<b>Well Name:</b> CO 10 15 FEDERAL COM	<b>Well Location:</b> T25S / R32E / SEC 10 / NENW / 32.150075 / -103.666296	<b>County or Parish/State:</b> LEA / NM
<b>Well Number:</b> 630H	<b>Type of Well:</b> OIL WELL	<b>Allottee or Tribe Name:</b>
<b>Lease Number:</b> NMLC061936	<b>Unit or CA Name:</b> COTTON DRAW UNIT	<b>Unit or CA Number:</b> NMNM70928X
<b>US Well Number:</b> 3002554204	<b>Operator:</b> CHEVRON USA INCORPORATED

**Type of Action:** APD Change

**Procedure Description:** Chevron U.S.A. Inc. is proposing to sundry CO 10 15 FEDERAL COM 630H in Cotton Draw to revise the well names, C102s, 9-point plans and directional drilling plan. Please note that some of the changes below have already been approved by the BLM but due to NMOCD records these changes need to be explicitly called out and approved by the BLM again. Well Name Change Current BLM Name: CO 10 15 FEDERAL COM 630H Current NMOCD Name: CO 3 34 FEDERAL 205H New BLM/NMOCD Name: CO 10 15 FEDERAL COM 630H Note: (the current NMOCD name is being included to correct NMOCD records) C102 changes Pool Code: Changing 96715 to 98270 Pool Name: Changing WC-025 G-06 S253209L; Bone Spring to WC-025 G-08 S253216D; Upper Wolfcamp Pro

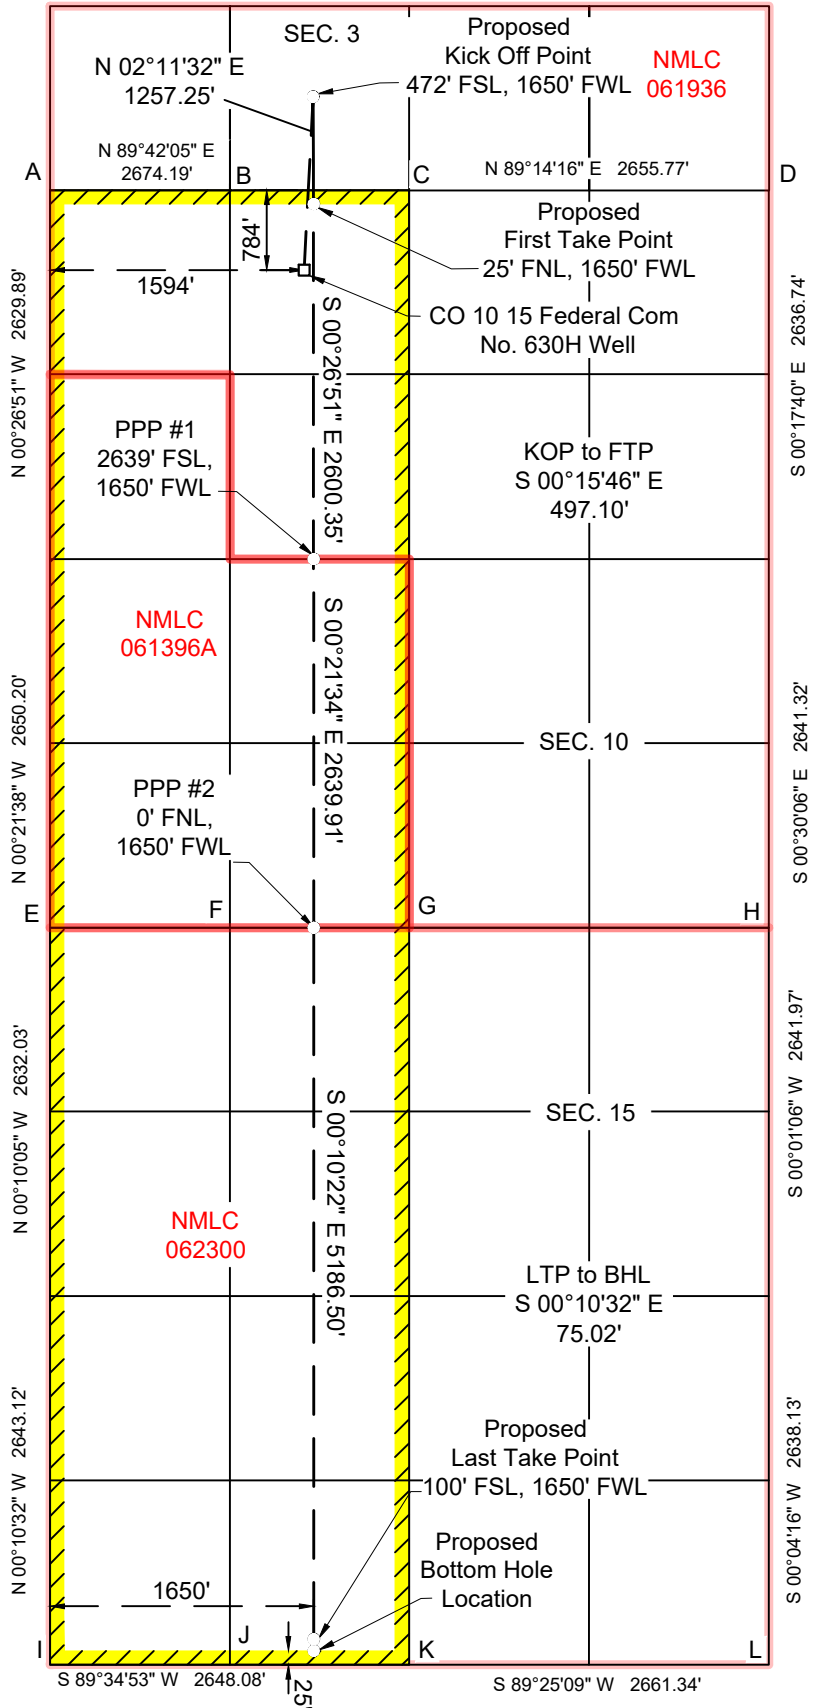
Pool Code: Changing 96715 to 98270

Pool Name: Changing WC-025 G-06 S253209L; Bone Spring to WC-025 G-08 S253216D; Upper Wolfcamp

Property Code: Changing 336509 to 338993

Property Name: Changing CO 3 34 FEDERAL to CO 10 15 FEDERAL COM

Surface Hole Location: Changing the north call from 791 to 784

Bottom Hole Location: Changing BHL from 25 from the north and 1430 from the west to 25 from the south and 1650 from the west

Dedicated Acreage: Changing 639.37 to 640

Kick off Point: Changing from 25 from the South and 1430 from the West of Section 3, T25S-R32E to 472 from the south and 1650 from the west of Section 3, T25S-R32E

First Take Point: Changing from 25 from the South and 1430 from the West of Section 3, T25S-R32E to 25 from the north and 1650 from the west of Section 10, T25S-R32E

Last Take Point: Changing from 100 from the north and 1430 from the West of Section 34, T24S-R32E to 100 from the south and 1650 from the west of Section 15, T25S-R32E

Project: Lea County, NM (NAD27 NME)  
 Site: CO Pad 627  
 Well: CO 10 15 Fed Com No. 630H  
 Wellbore: OH - 54204  
 Design: Plan 3 R1  
 Rig: Patterson 289

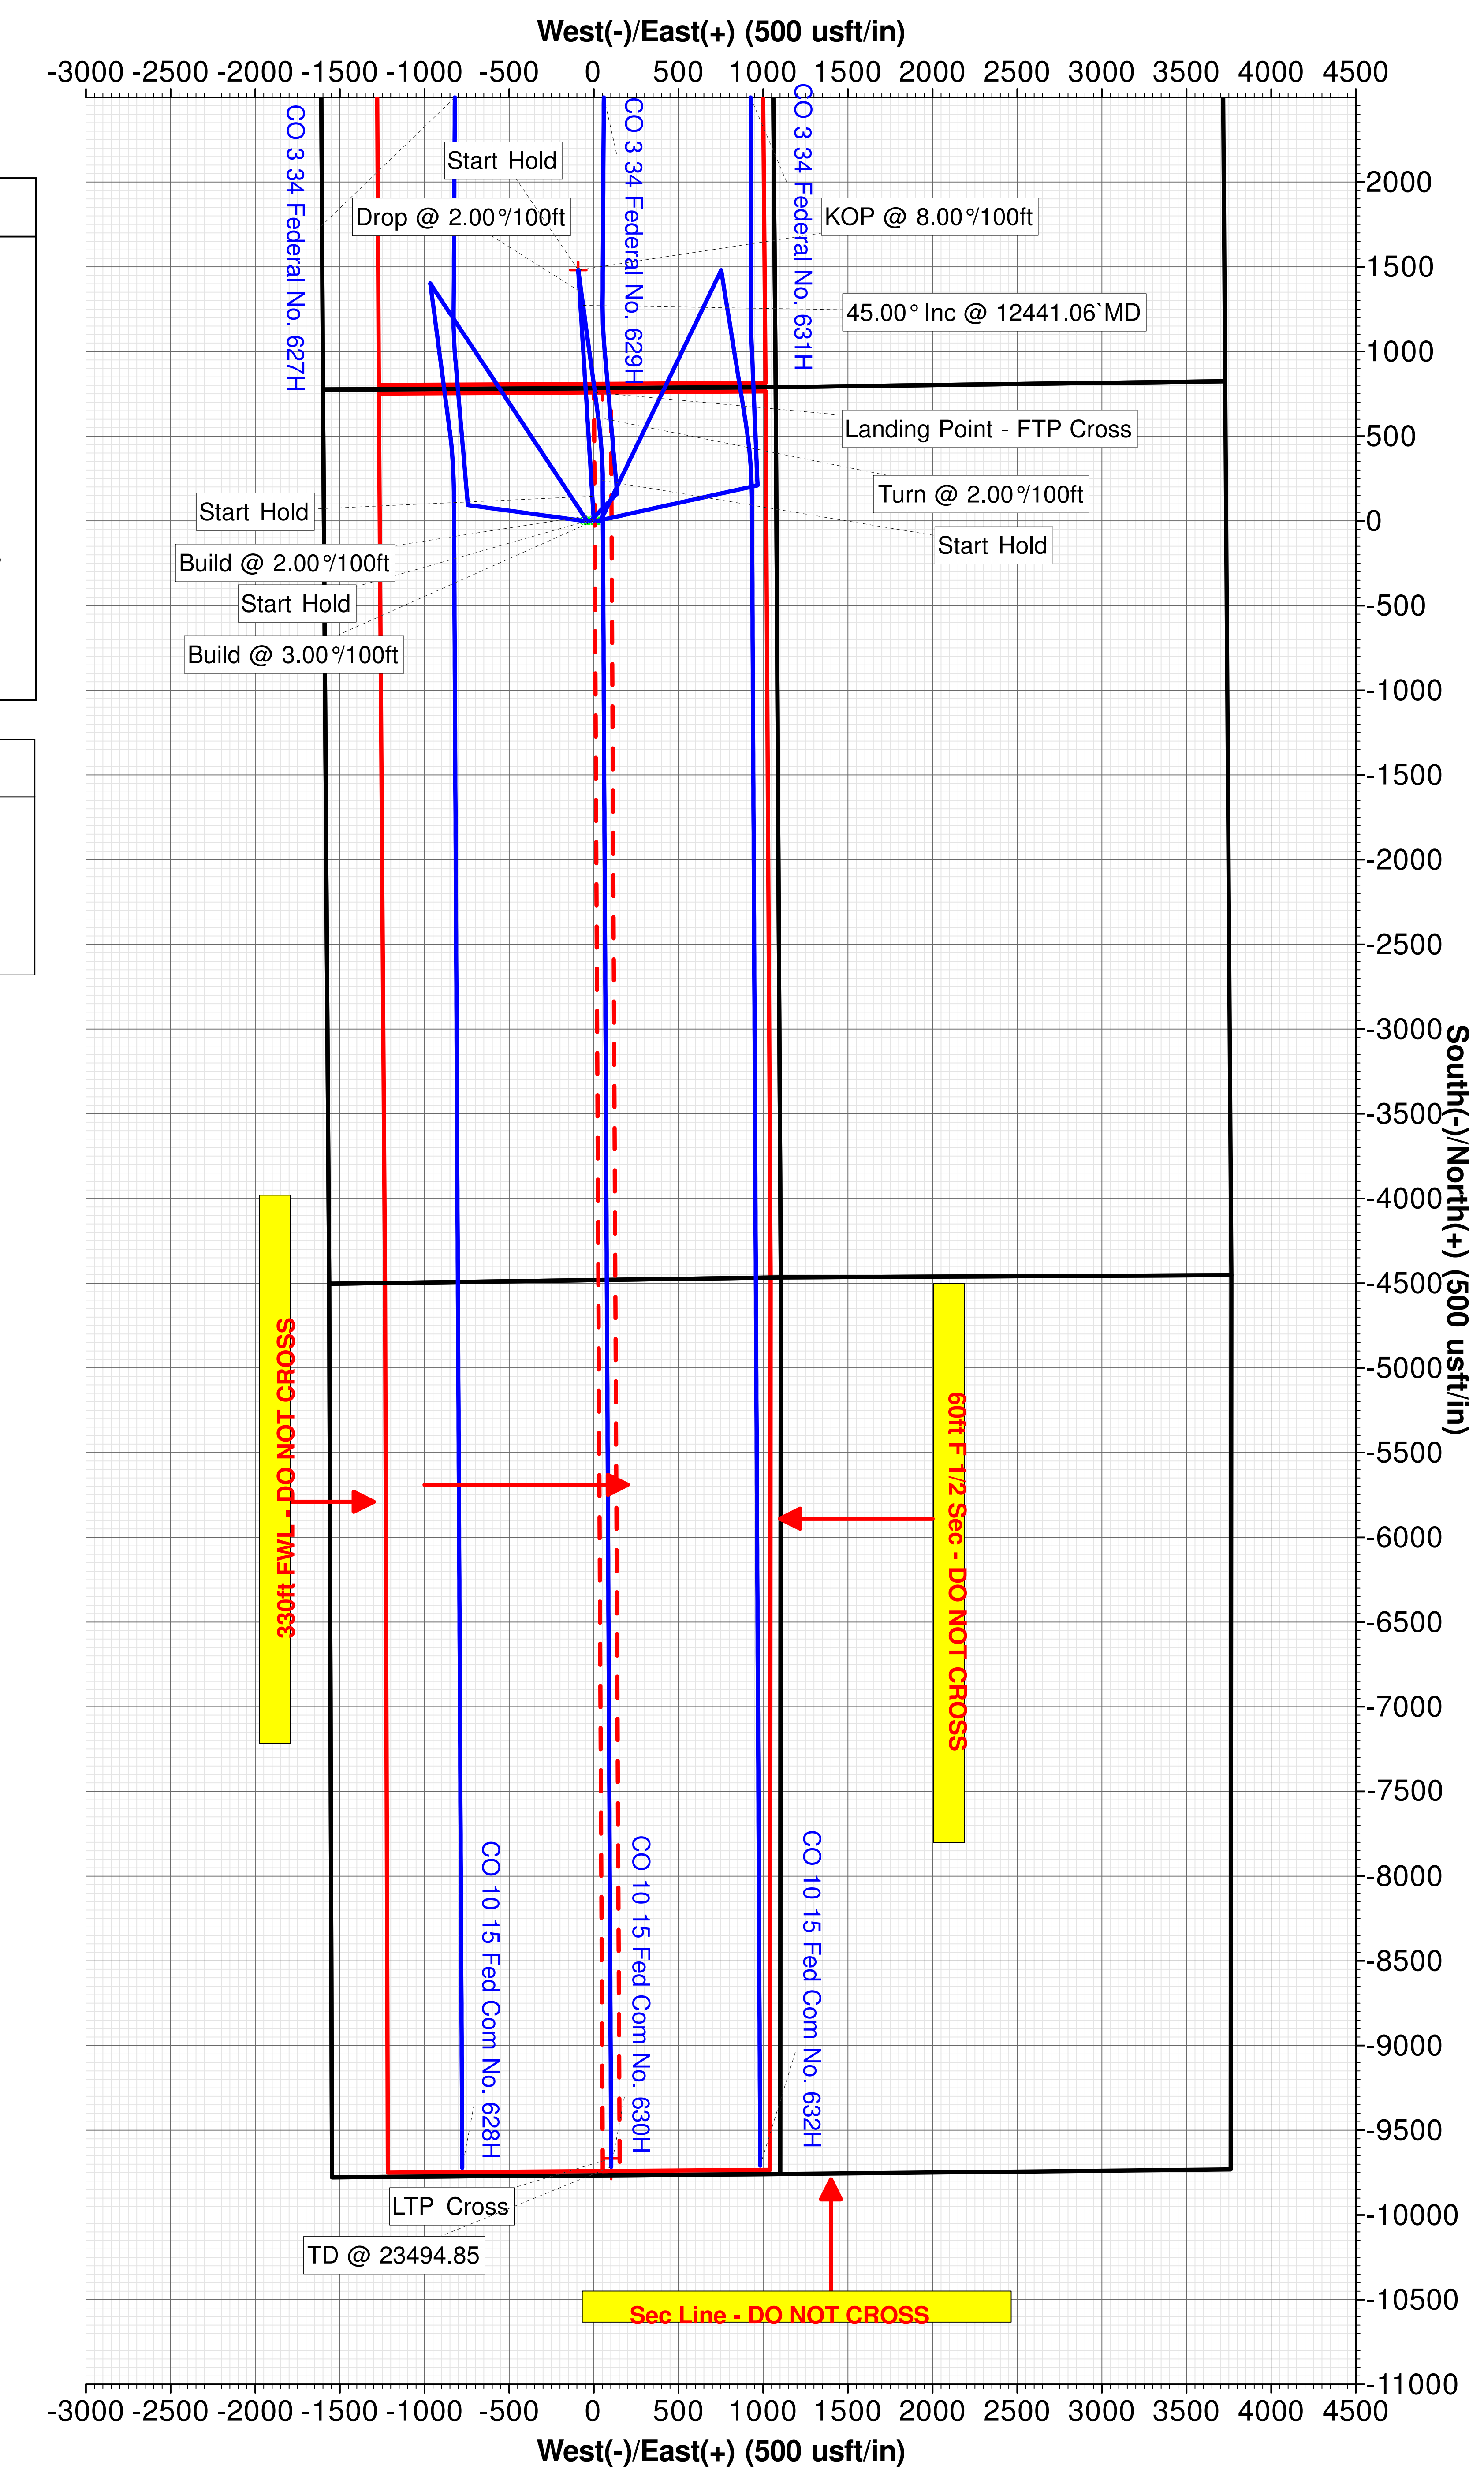
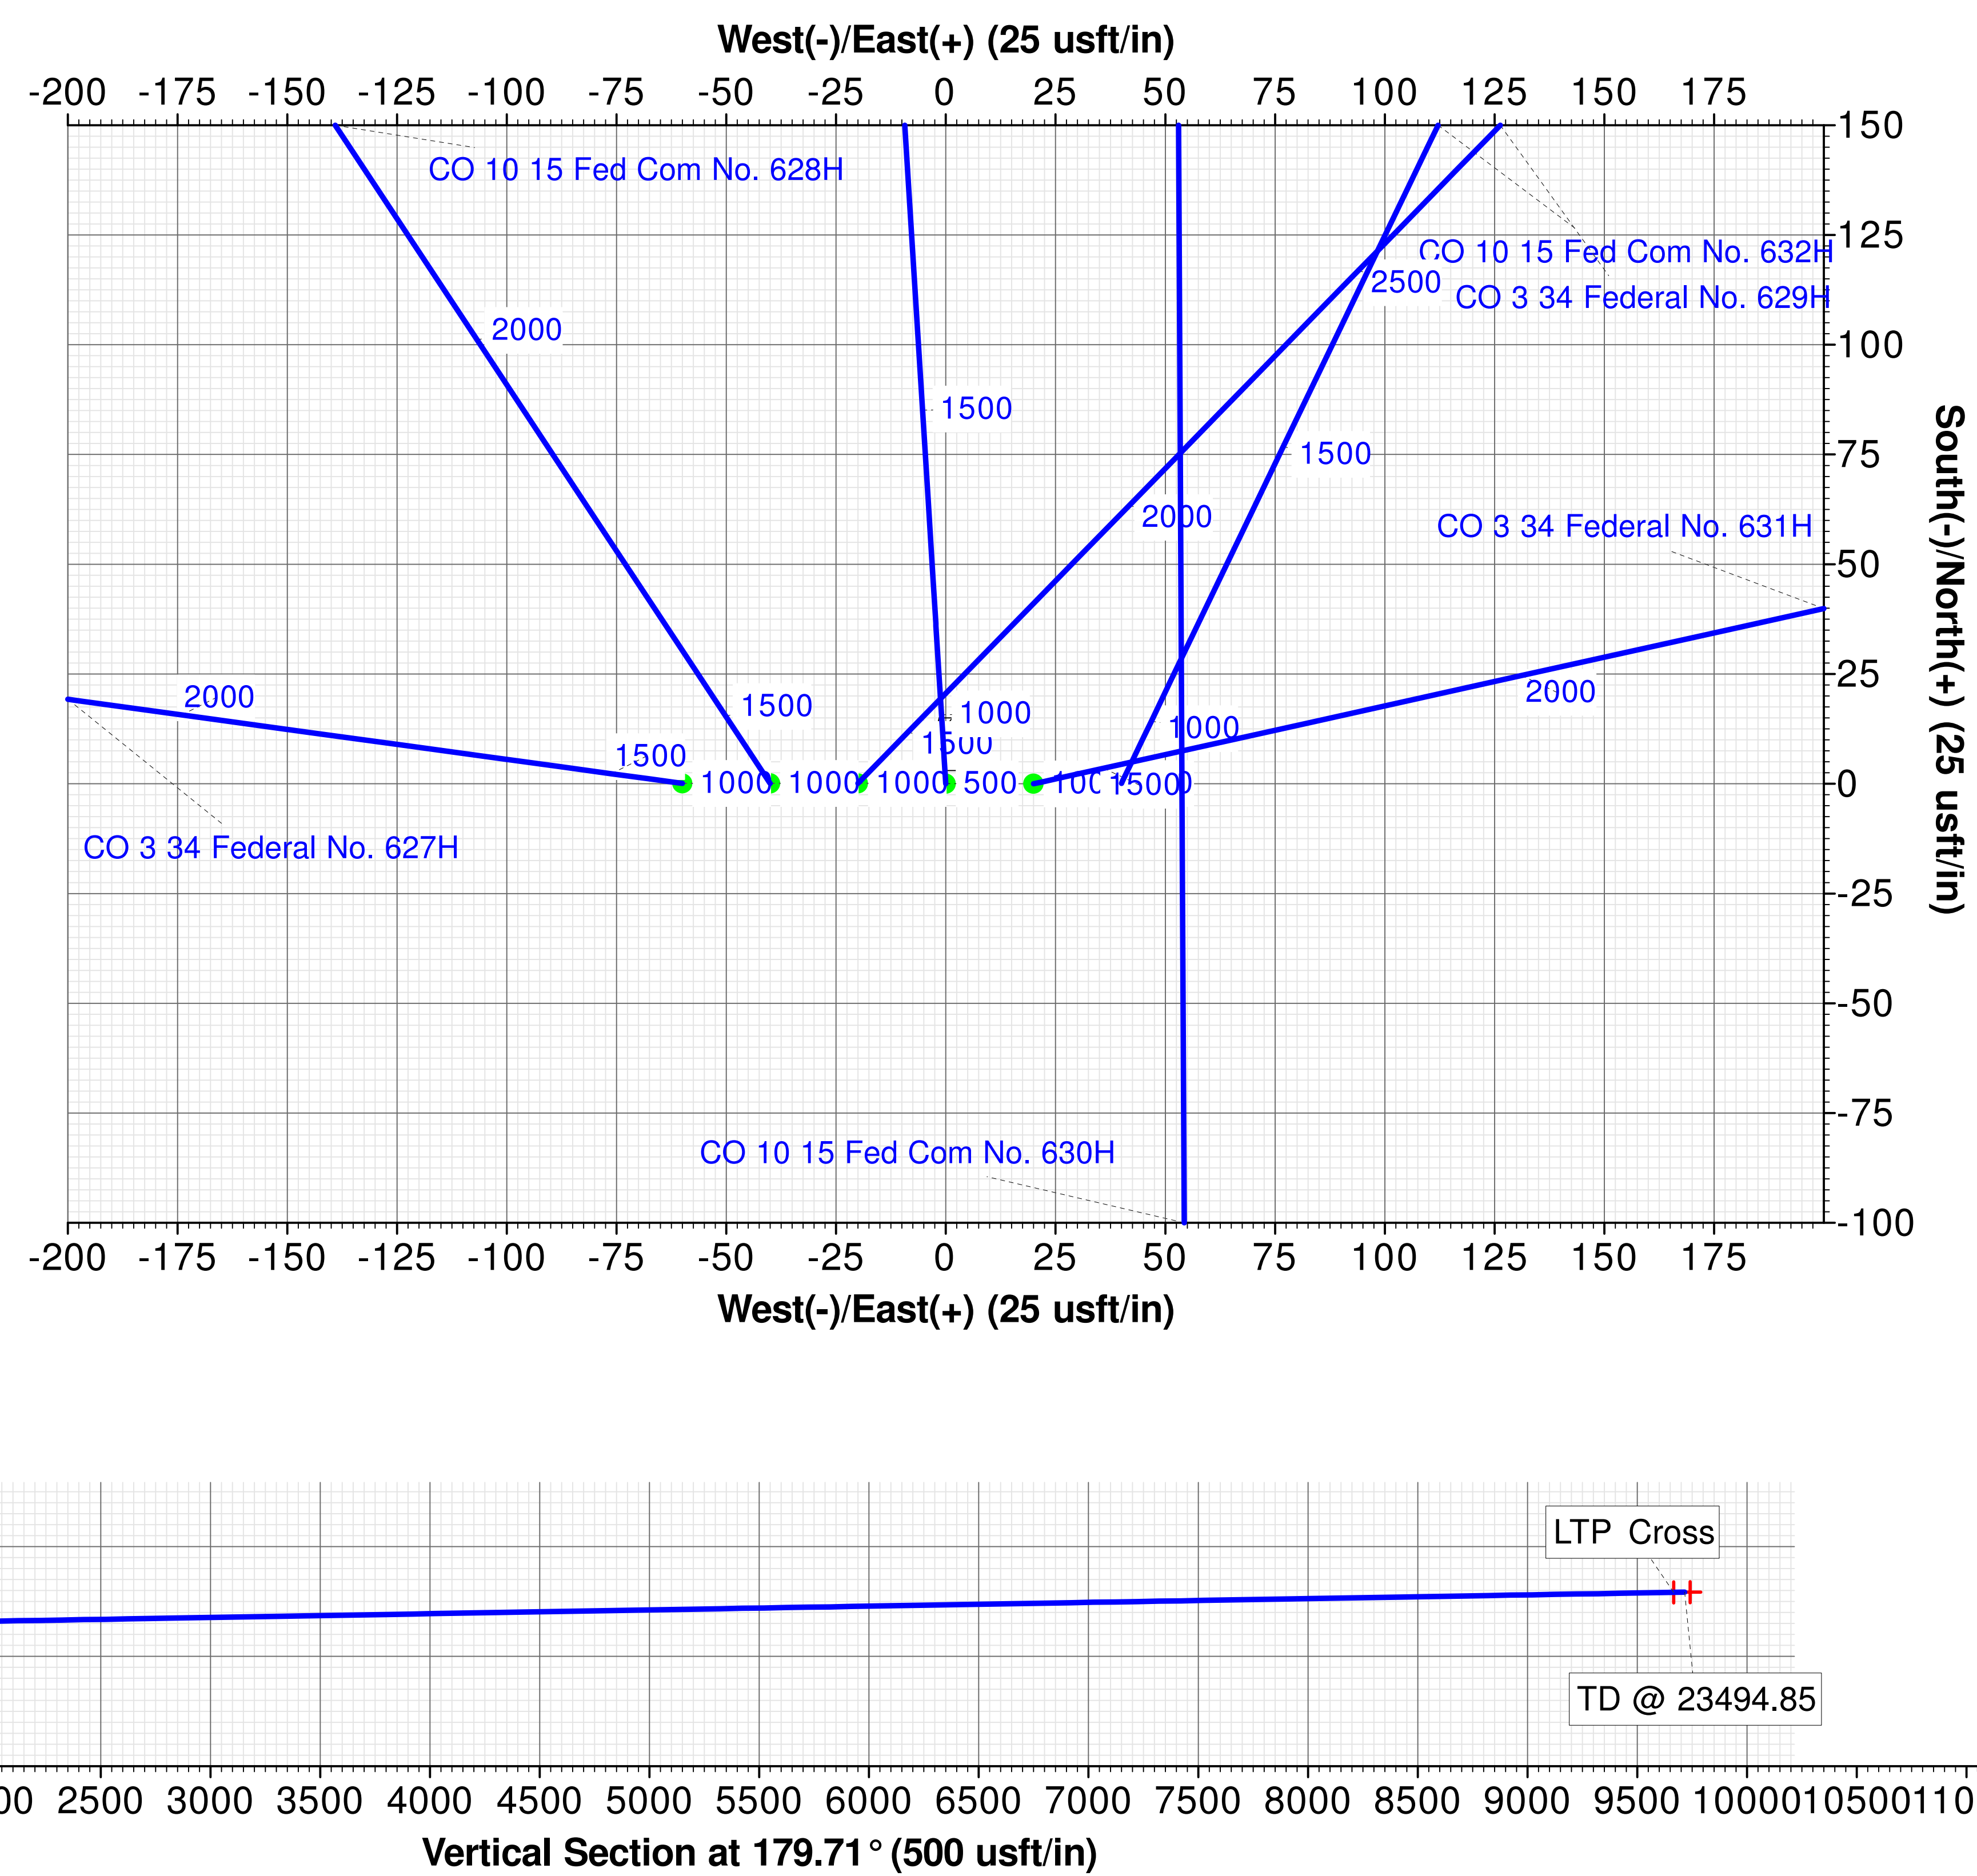
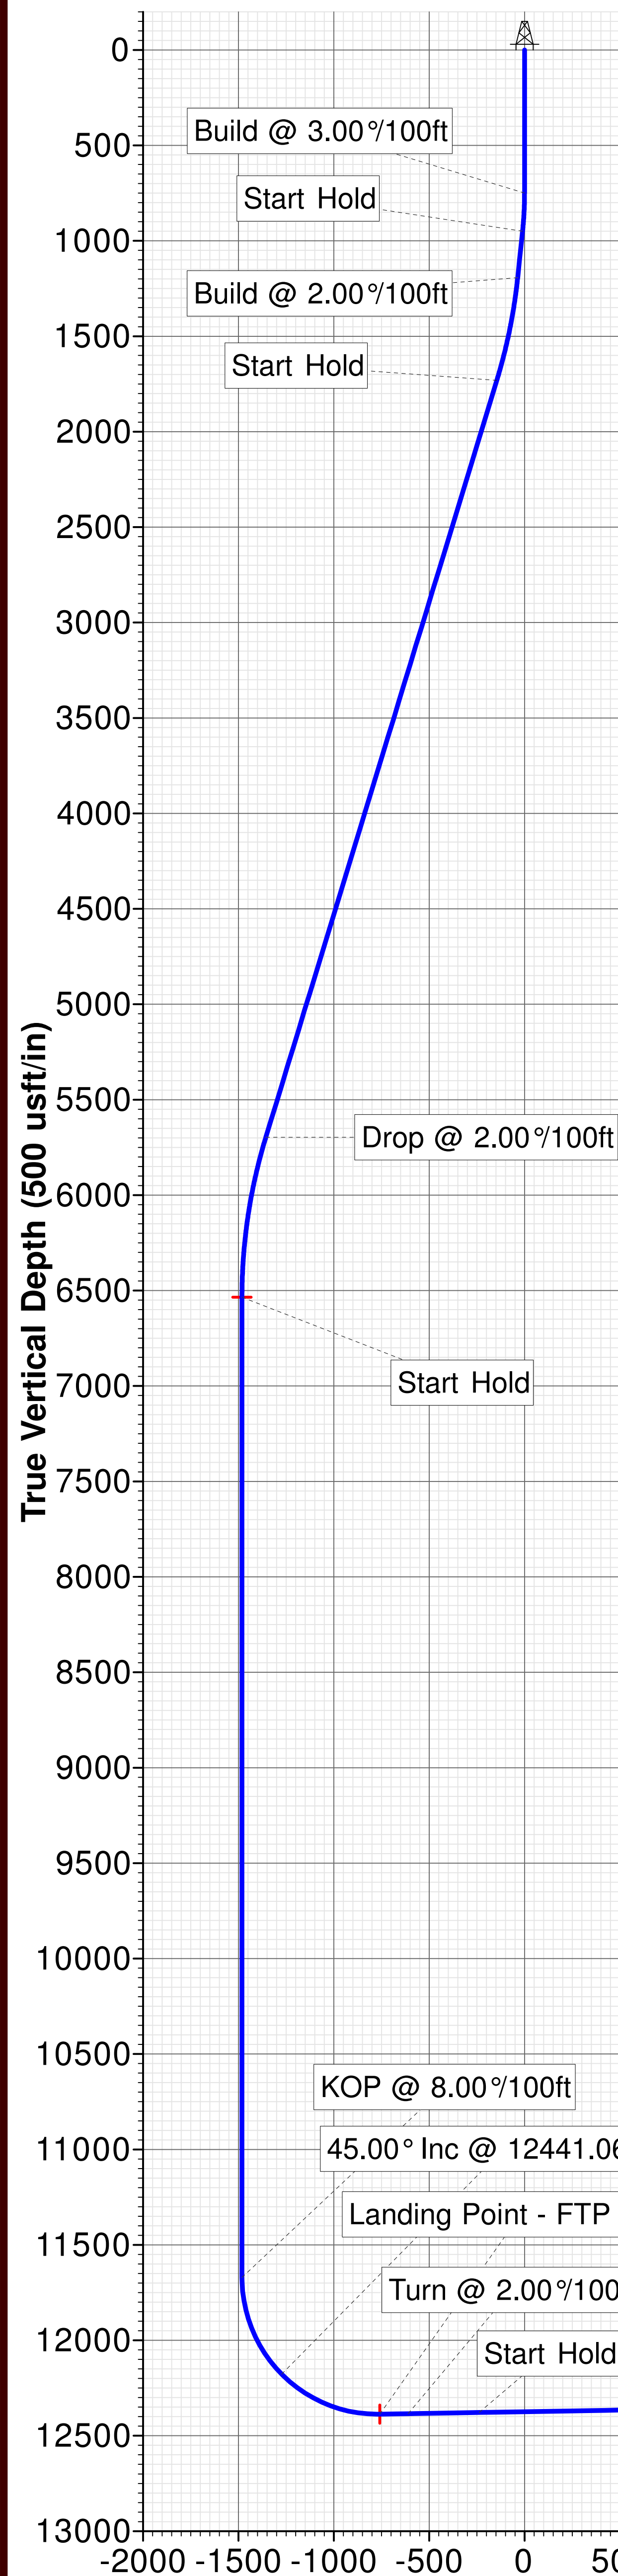
Updated Directional Drilling Plan
